# service bulletin

No. 93-20

## 1994 225 Update

### Mariner and Mercury

**Figure 1. Drain Hole Location View.**

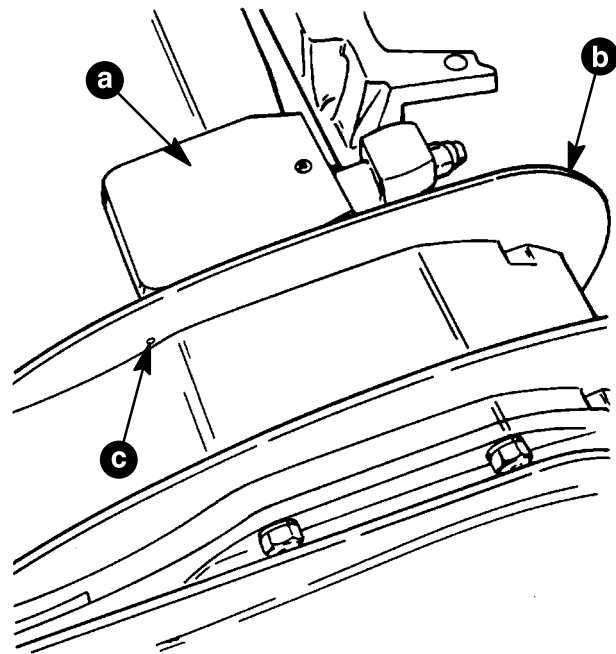
Inspect and, if necessary, remove the thin layer of aluminum covering the drive shaft housing drain holes. The drain holes are 1/8 inch (3.2 mm) in diameter. They are located under the splash plate on BOTH sides of the drive shaft housing and directly below the rear edge of lower mount cover. The holes allow water to drain from around the exhaust tube, when the engine is not running.

Failure to allow the water to drain from the cavity will cause the drive shaft housing to:

- corrode prematurely on the inside of the cavity in salt water.
- crack/break due to the formation of ice when exposed to freezing temperatures.

### Figure 2. Template

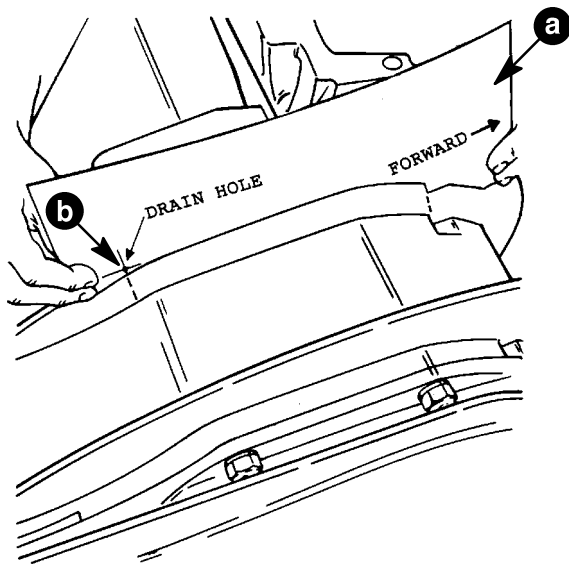
If either of the drain holes are not open, use the template provided to locate and open the drain holes. One template is provided for use on both sides of the drive shaft housing. Cut the template on the dotted line, punch a small hole in the center of the hole location dot, position the template on the drive shaft housing and mark the hole locations on BOTH sides of the drive shaft housing.

The material covering the cast-in drain holes is very thin and requires very little effort to remove. A small pointed punch and hammer are the best tools to break away the material covering the cast-in hole.

Paint the exposed aluminum edges of the hole to prevent corrosion. Illustrations are printed on the attached template.

Figure 3. Side View of CDM.

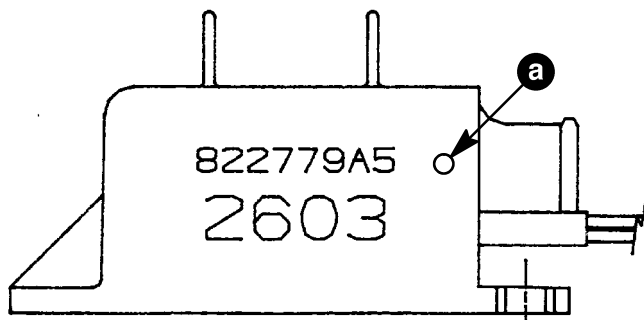
Replace all six CDM's. The improved CDM's are marked with a white dot after the cast-in part number or have a date code 2603 and above. Service part number is 822779A-2.

Figure 4. Bottom View of Drive Shaft Housing.

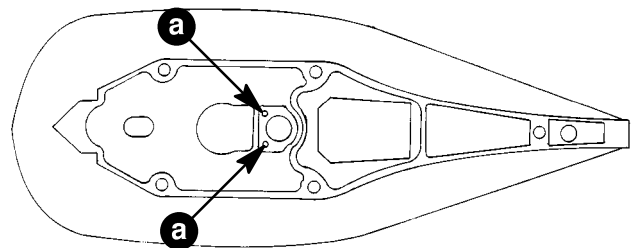
Remove the gear housing and drill two 0.250 inch (6.4 mm) water inlet holes. Drill the holes from the bottom side of the drive shaft housing in the flat area of the housing forward of the water tube. A drill extension or 12 inch (304.8 mm) long drill is required.

**Figure 5. Front View with Air Box Removed.**

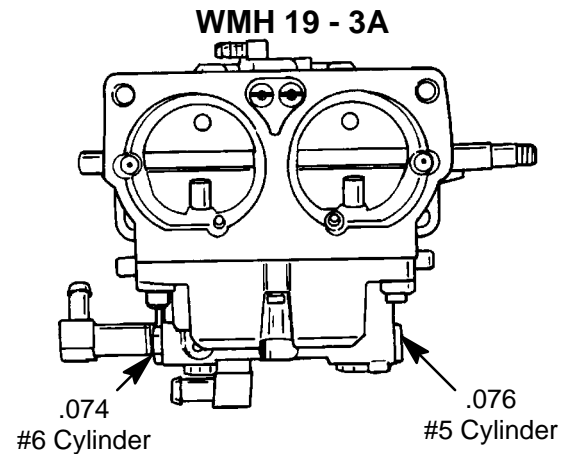
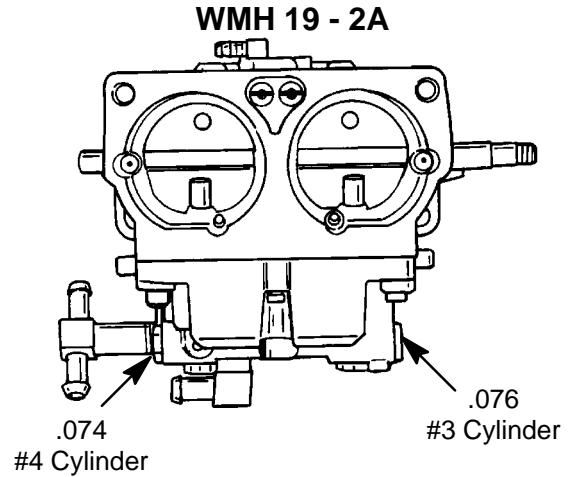
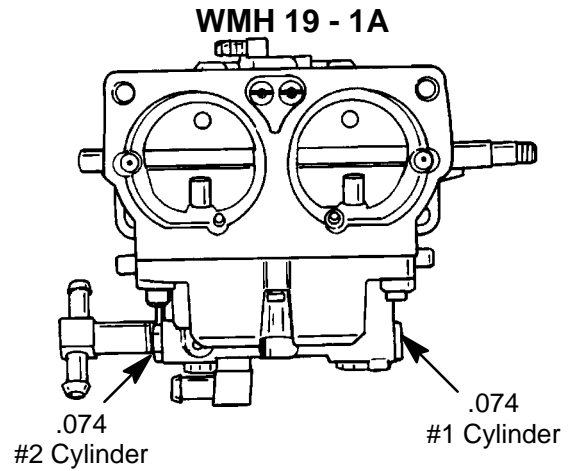
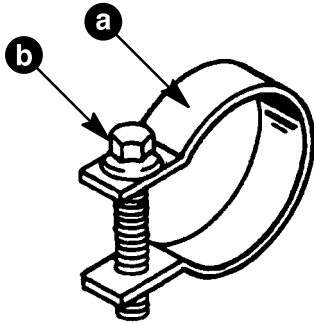
Install new main fuel jets for improved performance and optimized fuel economy. #1, #2, #4 and #6 cylinders require 0.074 main fuel jet (#4 Cylinder already has 0.074 main fuel jet installed). #3 and #5 cylinders require 0.076 main fuel jet. The main fuel jet is located behind the access plug. Order three (3) 0.074 jets p/n 1399-3794. Order one (1) 0.076 main fuel jet p/n 1399-3796 and use one (1) 0.076 jet that was removed from #6 cylinder location. Carburetors installed beginning with serial number 0G051097 have the new jets and are stamped with an "A".

Color the head of the main fuel jet access plugs black with a permanent marker to identify the jet change.

**Figure 6. Alternator Plug Clamp**

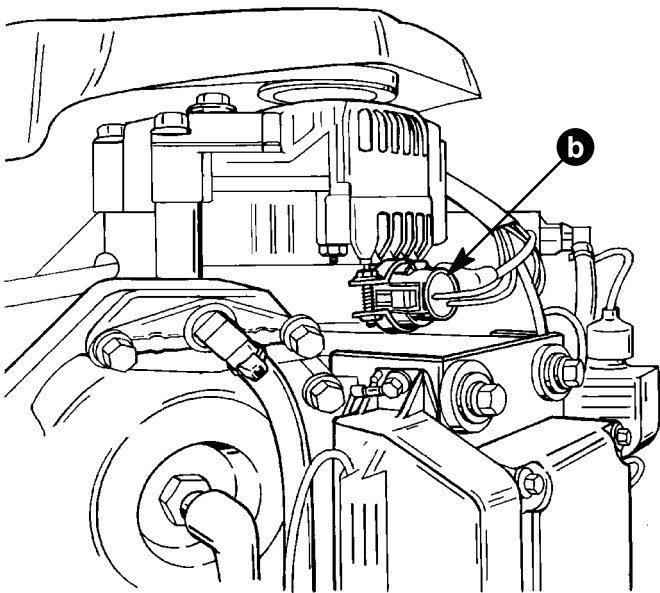
Install clamp and screw on the alternator electrical plug to prevent movement, due to vibration. Screw torque is 27 Lbs. In. (3 N-m).
